10.2 Turbine Generator

The information in this section of the reference ABWR DCD, including all subsections, tables and figures, is incorporated by reference with the following departures and supplements.

Figure 10.2-1 Turbine Stop Valve Closure Characteristic

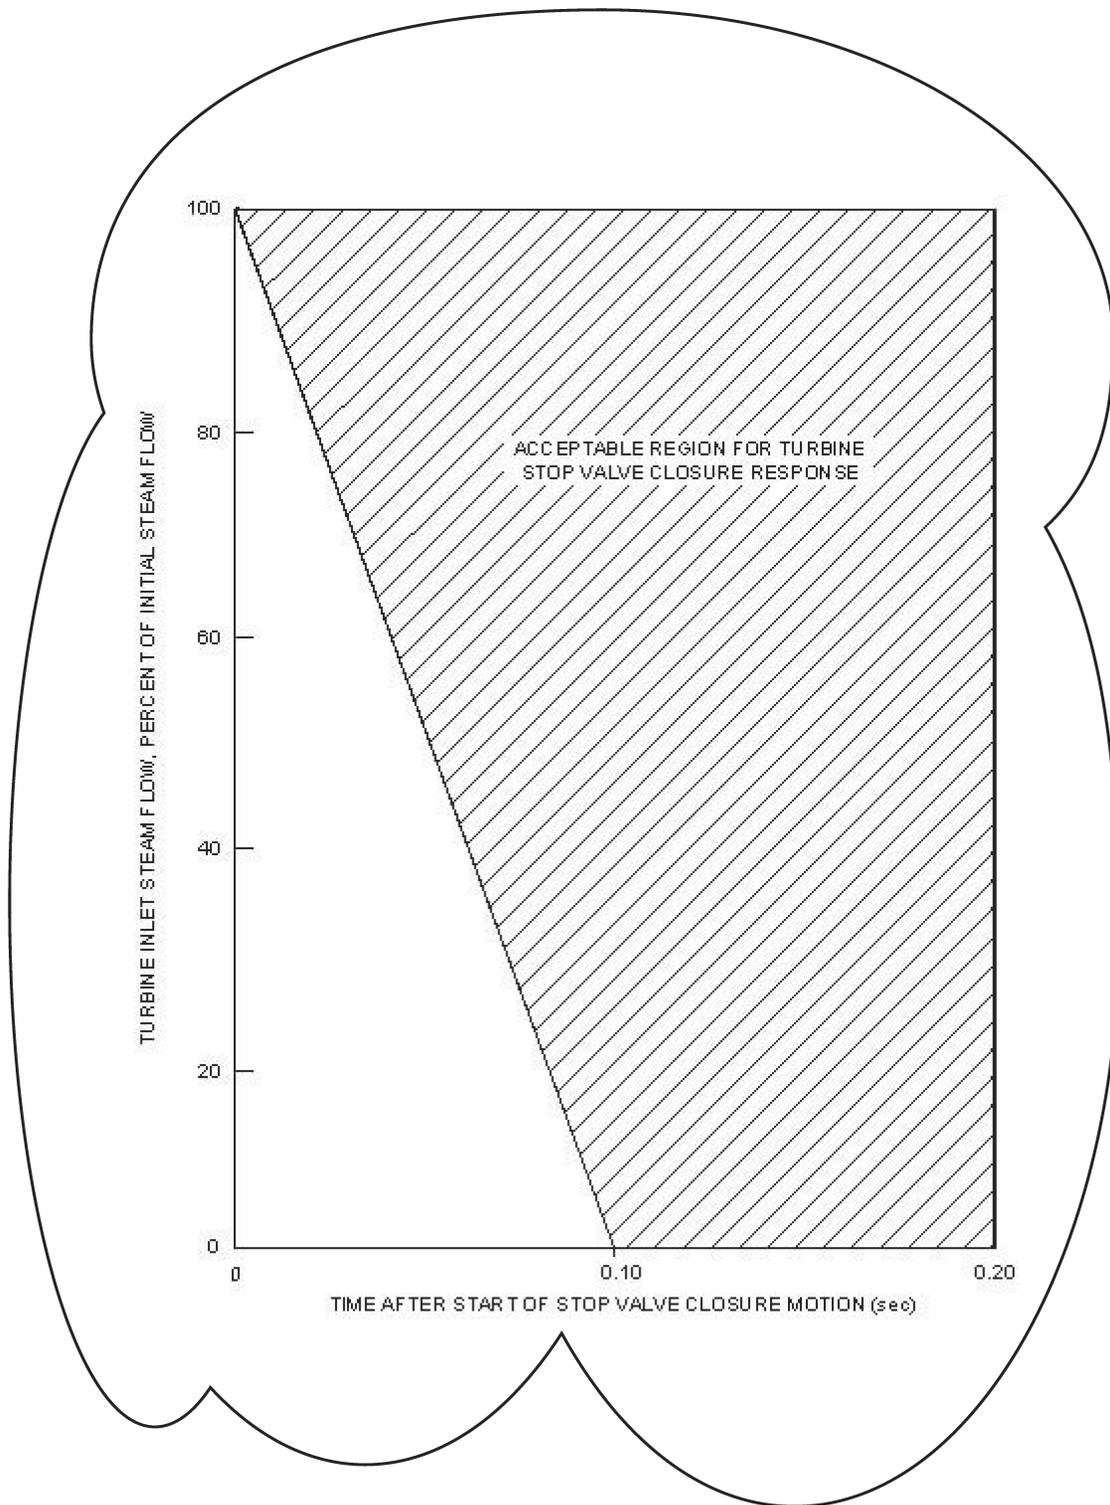
STD DEP Admin (Figure 10.2-1)

Figure 10.2-5 Turbine Overspeed Trip System Functional Diagram

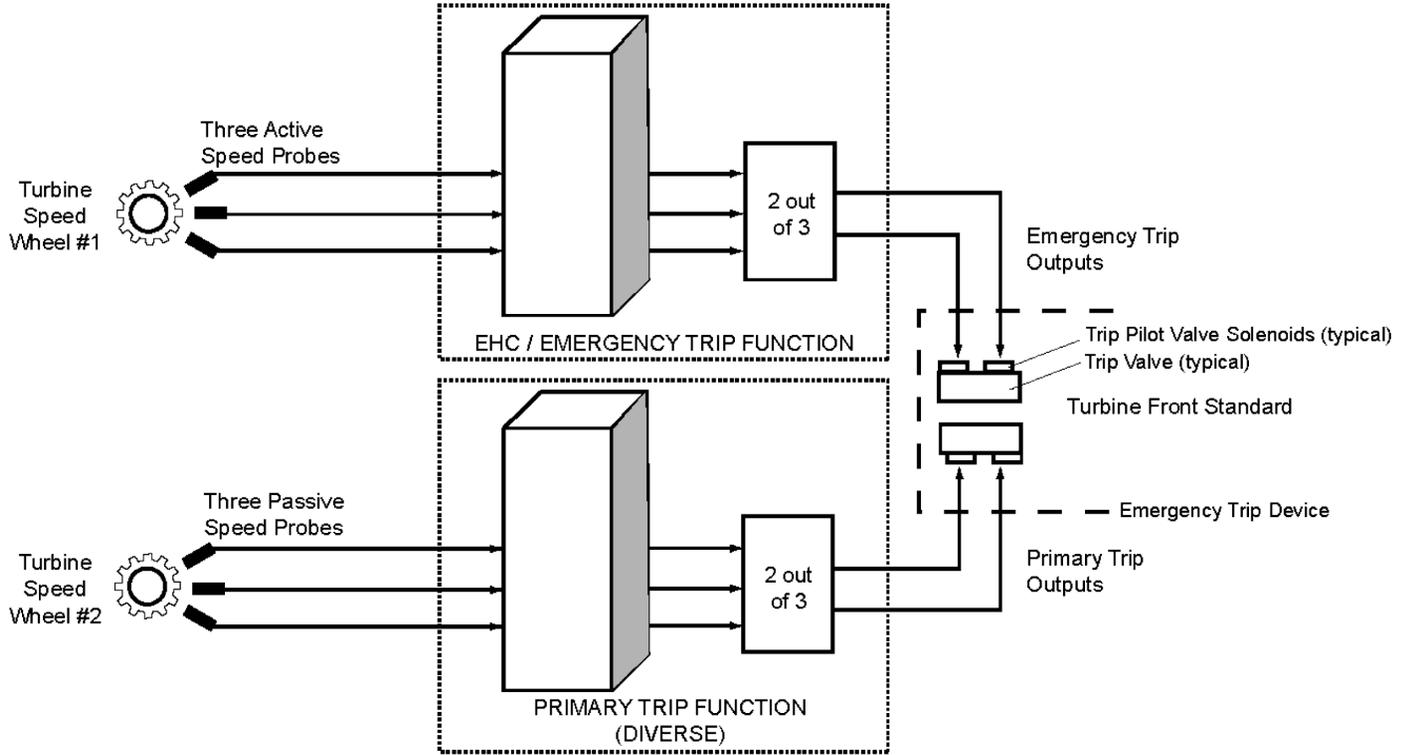
The primary trip function is independent and diverse from the emergency trip function as explained below (refer to Figure 10.2-5, Turbine Overspeed Trip System Functional Diagram). Two-out-of-three logic is employed in both the primary and emergency overspeed trip circuitry. Each trip function can de-energize its associated trip pilot valve solenoids of the electro-hydraulic Emergency Trip Device (ETD). The ETD is composed of two independent trip valves, each with two normally energized fail-safe solenoids. For each trip valve, each trip pilot valve solenoid is powered from a separate power source. The solenoids de-energize in response to detection of an overspeed condition by the turbine speed control logic. De-energization of both trip pilot valve solenoids is necessary to cause the spool in their respective trip valve to reposition, which depressurizes the emergency trip fluid system, rapidly closing all steam inlet valves and indirectly closing the steam extraction nonreturn valves. Accordingly, the repositioning of only one of the two trip valves is necessary to trip the main turbine. A single electrical component failure does not compromise trip protection, and does not result in a turbine trip. Each trip valve in the ETD is testable while the turbine is in operation.

The diverse primary overspeed trip function utilizes three passive speed sensors that are separate from the active speed sensors used for normal speed control and emergency trip function. Speed sensors are diverse (passive and active sensors) between primary overspeed and emergency overspeed trip. Speed sensing for primary

and emergency overspeed trip functions also use separate speed wheels (refer to Figure 10.2-5). Each speed signal for the primary trip function is compared to a speed setpoint of approximately 110% of rated speed, and produces trip signals arranged in two-out-of-three logics, to de-energize both trip pilot valve solenoids of one of the two trip valves of the ETD. Both trip pilot valve solenoids must be de-energized to trip the associated trip valve. The ETD has two redundant trip valves. Tripping of either redundant trip valve will drain the emergency trip fluid, resulting in a turbine trip.
